T-PVS/Files(2021)23

**Presumed threat to Emerald site
“Bugzkyi Gard National Nature Park”
(UA0000040)
(Ukraine)**

Appendix 1: Comments on the Environmental Impact Assessment Report for the Tashlyk Pumped Storage Power Plant Completion Project

Figure 1. Projected changes in mean annual river discharge simulated by the WaterGAP2 model. Res: Footnote 4.

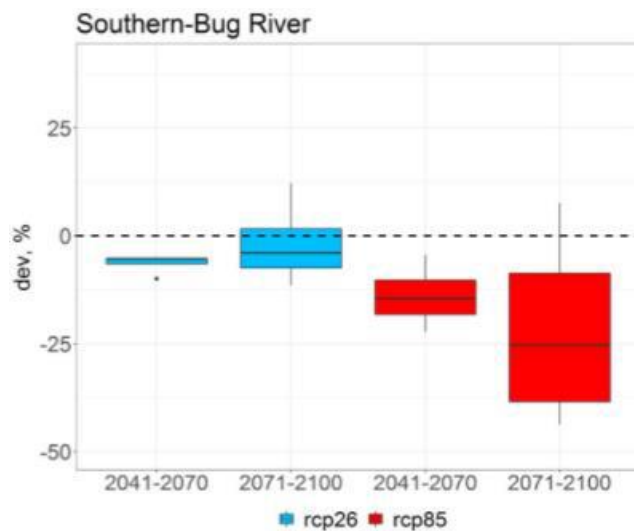
Simulations of climate-related future river discharge revealed reduction of Pivdennyi Buh River's mean annual discharge. In the period 2041-70, it will be insignificant, but still up to minus ten per cent⁶. The worst scenario for the Pivdennyi Buh brings reduction of mean annual discharge reaching up to -30 % to the end of the century if greenhouse gas emissions not reduced⁷. Such a considerable discharge reduction would also have a profound impact on the very operation and capacity of the Tashlyk plant, which the Report also fails to mention. Solar and wind-powered renewable energetics are an alternative solution that not only levels the climate-related risks, but presents a solution for climate crisis by itself. Industrial-scale photovoltaics, if installed in place of the reservoir can generate up to 7 times the current hydropower generated by the hydro power plants. Let alone that the efficiency of Li-ion batteries is up to 95%⁹, while the Tashlyk plant can do only 65%.
